Prairie Island Nuclear Generating Plant Units 1 and 2
Dockets 50-282 and 50-306
License Nos. DPR-42 and DPR-60

Response to NRC Request for Additional Information Regarding Application for
Renewed Operating Licenses

Enclosure 1
Response to Follow-up RAI B2.1.38

Figure 1 Weight Loss in Acid vs. Volume Fraction of Cement (based on data from Reference 7)

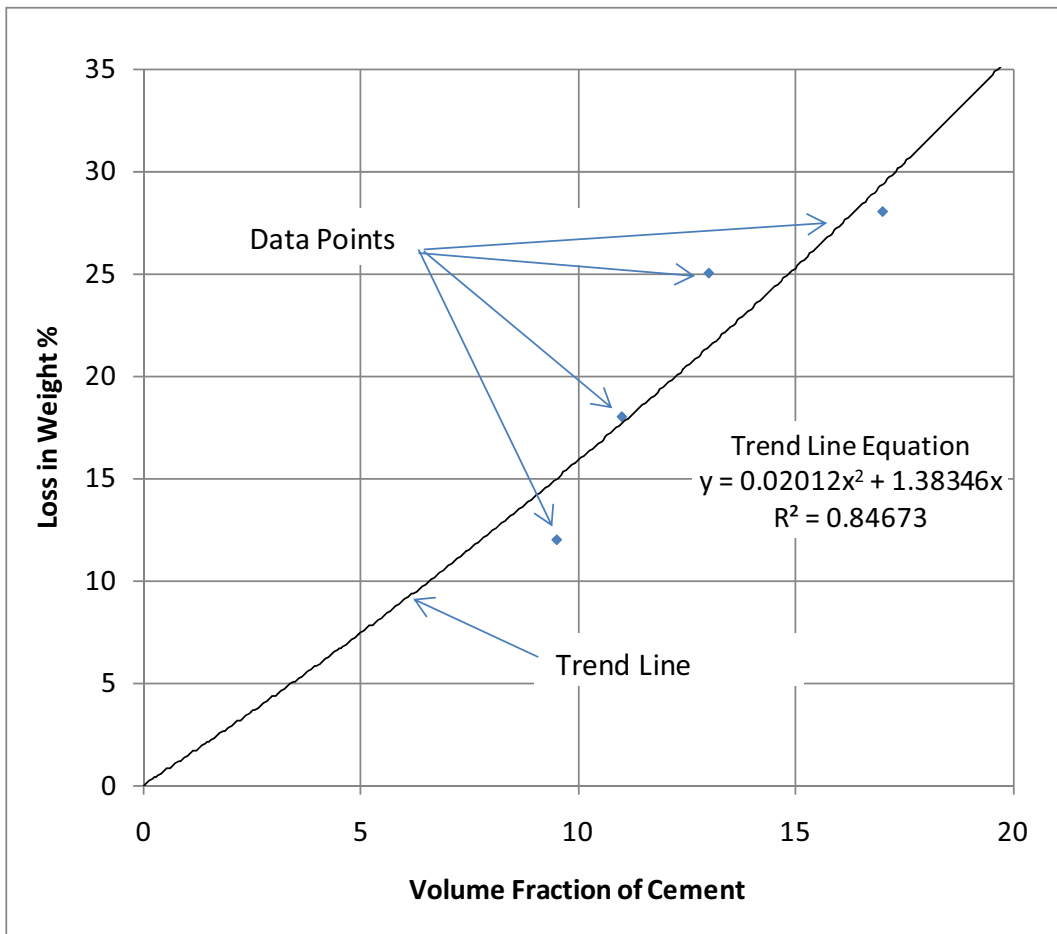
d) In Section 5.2.3 of Reference 1, the rate of degradation estimated for PINGP concrete is two times that used previously for Salem/Connecticut Yankee plants to account for the difference in the type of concrete aggregates at PINGP. Please advise if NSPM has performed or intends to perform any tests to confirm the use of this assumption for the degradation rate.

The acceleration factor of 2.0 for the increased rate of degradation resulting from the presence of about 5% carbonate-based aggregate at Prairie Island relative to the 0% carbonate-based aggregate at the cited plants was based on engineering judgment.

of Reference 6). Tests discussed in Reference 7 indicate that the weight loss experienced by cubes of concrete immersed in acid increases as the volume fraction of cement in the concrete increases. These tests were performed on concrete that had non-soluble aggregate (i.e., only siliceous aggregate and no calcium carbonate-based aggregate). This increased weight loss is attributed to the fact that, as the volume fraction of cement increases, the volume fraction of the concrete that is soluble in acids increases. Based on this result, it is reasonable to assume that the effect of boric acid on concrete containing soluble aggregates will follow a similar pattern; i.e., the degradation of concrete due to boric acid will increase as the total fraction of material in the concrete that is soluble in acids increases, whether that soluble material is cement or aggregate.

Quantitative data in Reference 7 for weight loss of concrete cubes when exposed to an acid concentration of 3% is shown in Figure 1. A trend line is shown on the figure that provides an equation for quantifying this dissolution behavior. As can be seen, the weight loss increases somewhat more strongly than linearly as the volume fraction of cement, (i.e., of soluble material), increases.

A footnote on page 10 of Reference 4 indicates that concrete normally contains 10 to 15% of cement, or an average of about 12.5%. As noted on page 2-2 of Reference 1, the amount of carbonaceous aggregate in the concrete used at Prairie Island was about 5%. Adding this 5% to the average 12.5% cement results in a total of 17.5% soluble material in the concrete at Prairie Island as compared to the 12.5% in a concrete with all igneous (no carbonate) based aggregate such as was used at the cited plants. (Section 8.1.3 of Reference 8) Using the trend line equation shown in Figure 1, increasing the fraction of soluble material (cement in the figure, cement plus soluble aggregate in this case) from 12.5% to 17.5% increases the weight loss by a factor of 1.49. This indicates that the assumed factor of 2.0 increase in severity of acid attack to account for the presence of 5% carbonate-based aggregate is conservative by a significant margin (2 vs. 1.49).

General Arrangement of Change Fixture Supports

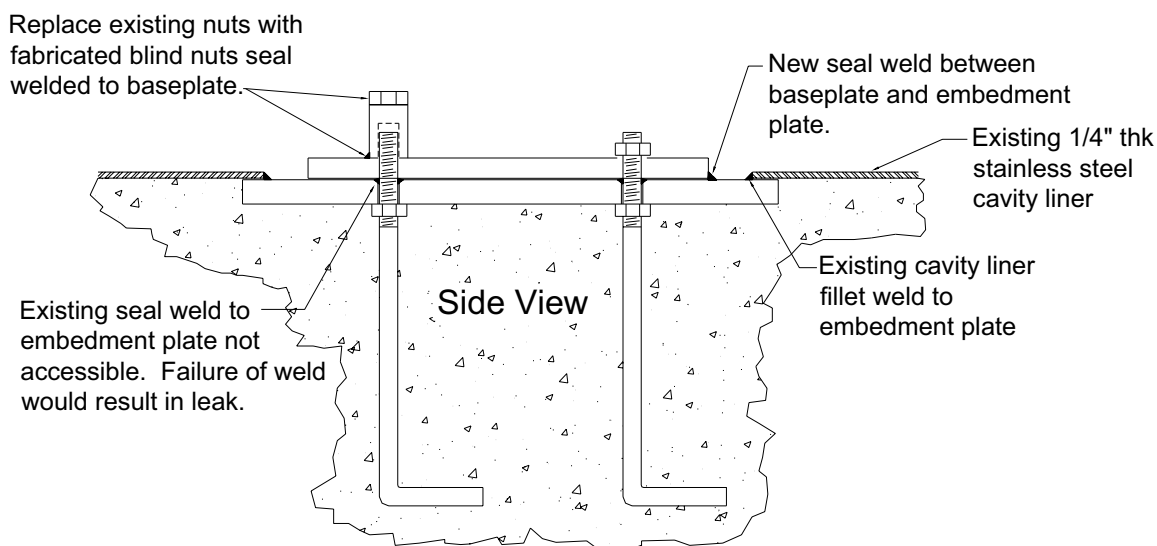
- i) Page 52 of Reference 2 identified five recommendations to address reactor cavity leakage. Please provide NSPM's action plan and schedule for completing these five recommendations.

The RCE concluded that the most likely refueling cavity leakage points are where the anchor studs for the reactor internals stands and the Rod Control Cluster (RCC) Change Fixture penetrate the associated embedment plates. The studs for these fixtures pass through holes in the embedment plates and are seal welded on the underside for the internals storage stands, and on top (then ground flush) for the RCC Change Fixture. Pinhole leaks or small cracks in one or more of the seal welds would result in a leak path through the embedment plate along the threads of the studs, allowing water under the cavity liner.

The plant management review of the Root Cause Evaluation considered the value, need and sufficiency of each recommendation. The current repair plan that emerged from these reviews is to replace the existing anchor nuts with new fabricated blind nuts that are seal welded to the existing baseplates. In addition, the existing baseplates will be seal welded to the embedment plates. The new welds will be readily accessible for examination to ensure the existing anchors and baseplates are leak tight. The following sketch depicts a typical RCC change fixture support showing the planned repairs. Similar repairs will be made to the internals stands supports.

Figure 1 Weight Loss in Acid vs. Volume Fraction of Cement (based on data from Reference 7)

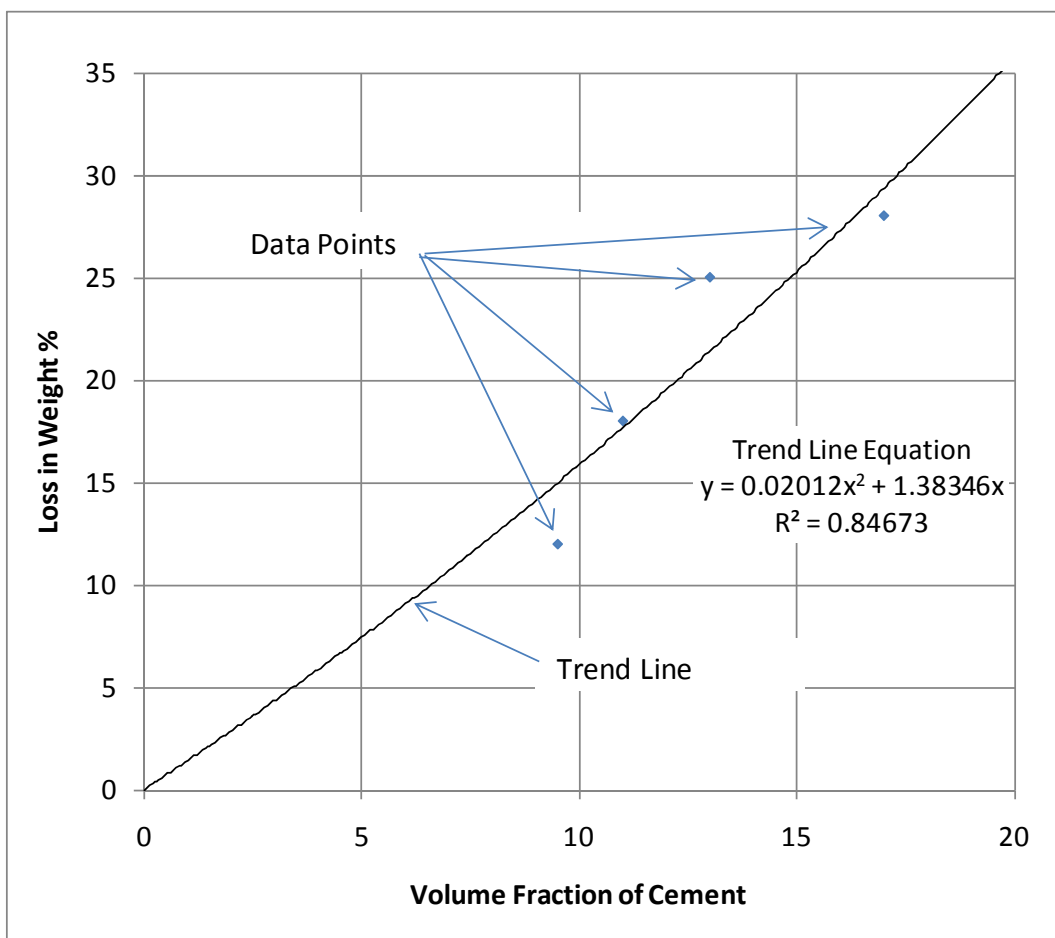
d) In Section 5.2.3 of Reference 1, the rate of degradation estimated for PINGP concrete is two times that used previously for Salem/Connecticut Yankee plants to account for the difference in the type of concrete aggregates at PINGP. Please advise if NSPM has performed or intends to perform any tests to confirm the use of this assumption for the degradation rate.

The acceleration factor of 2.0 for the increased rate of degradation resulting from the presence of about 5% carbonate-based aggregate at Prairie Island relative to the 0% carbonate-based aggregate at the cited plants was based on engineering judgment.

of Reference 6). Tests discussed in Reference 7 indicate that the weight loss experienced by cubes of concrete immersed in acid increases as the volume fraction of cement in the concrete increases. These tests were performed on concrete that had non-soluble aggregate (i.e., only siliceous aggregate and no calcium carbonate-based aggregate). This increased weight loss is attributed to the fact that, as the volume fraction of cement increases, the volume fraction of the concrete that is soluble in acids increases. Based on this result, it is reasonable to assume that the effect of boric acid on concrete containing soluble aggregates will follow a similar pattern; i.e., the degradation of concrete due to boric acid will increase as the total fraction of material in the concrete that is soluble in acids increases, whether that soluble material is cement or aggregate.

Quantitative data in Reference 7 for weight loss of concrete cubes when exposed to an acid concentration of 3% is shown in Figure 1. A trend line is shown on the figure that provides an equation for quantifying this dissolution behavior. As can be seen, the weight loss increases somewhat more strongly than linearly as the volume fraction of cement, (i.e., of soluble material), increases.

A footnote on page 10 of Reference 4 indicates that concrete normally contains 10 to 15% of cement, or an average of about 12.5%. As noted on page 2-2 of Reference 1, the amount of carbonaceous aggregate in the concrete used at Prairie Island was about 5%. Adding this 5% to the average 12.5% cement results in a total of 17.5% soluble material in the concrete at Prairie Island as compared to the 12.5% in a concrete with all igneous (no carbonate) based aggregate such as was used at the cited plants. (Section 8.1.3 of Reference 8) Using the trend line equation shown in Figure 1, increasing the fraction of soluble material (cement in the figure, cement plus soluble aggregate in this case) from 12.5% to 17.5% increases the weight loss by a factor of 1.49. This indicates that the assumed factor of 2.0 increase in severity of acid attack to account for the presence of 5% carbonate-based aggregate is conservative by a significant margin (2 vs. 1.49).

General Arrangement of Change Fixture Supports

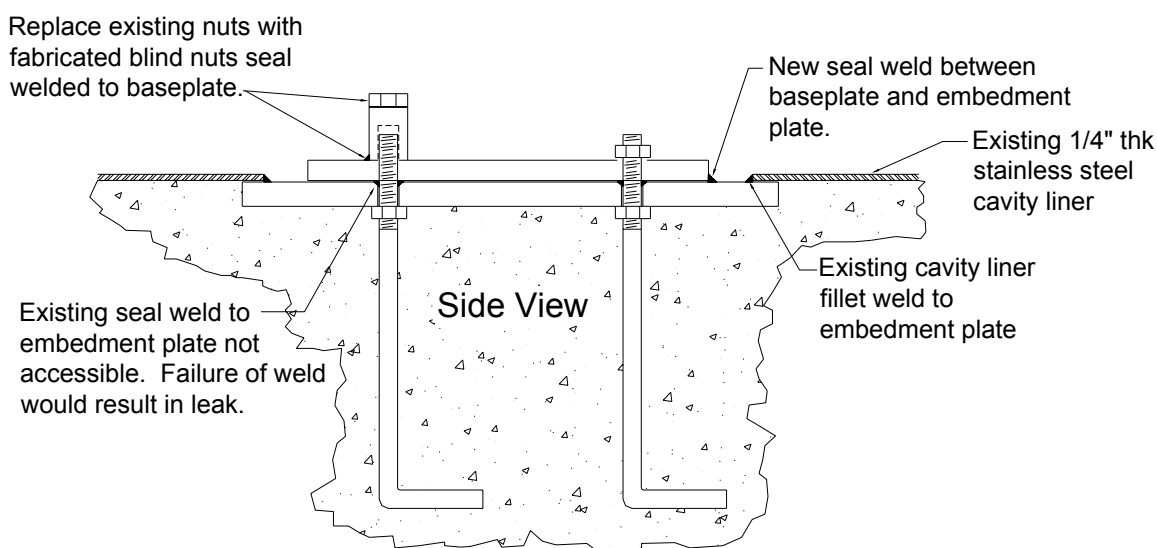
- i) Page 52 of Reference 2 identified five recommendations to address reactor cavity leakage. Please provide NSPM's action plan and schedule for completing these five recommendations.

The RCE concluded that the most likely refueling cavity leakage points are where the anchor studs for the reactor internals stands and the Rod Control Cluster (RCC) Change Fixture penetrate the associated embedment plates. The studs for these fixtures pass through holes in the embedment plates and are seal welded on the underside for the internals storage stands, and on top (then ground flush) for the RCC Change Fixture. Pinhole leaks or small cracks in one or more of the seal welds would result in a leak path through the embedment plate along the threads of the studs, allowing water under the cavity liner.

The plant management review of the Root Cause Evaluation considered the value, need and sufficiency of each recommendation. The current repair plan that emerged from these reviews is to replace the existing anchor nuts with new fabricated blind nuts that are seal welded to the existing baseplates. In addition, the existing baseplates will be seal welded to the embedment plates. The new welds will be readily accessible for examination to ensure the existing anchors and baseplates are leak tight. The following sketch depicts a typical RCC change fixture support showing the planned repairs. Similar repairs will be made to the internals stands supports.
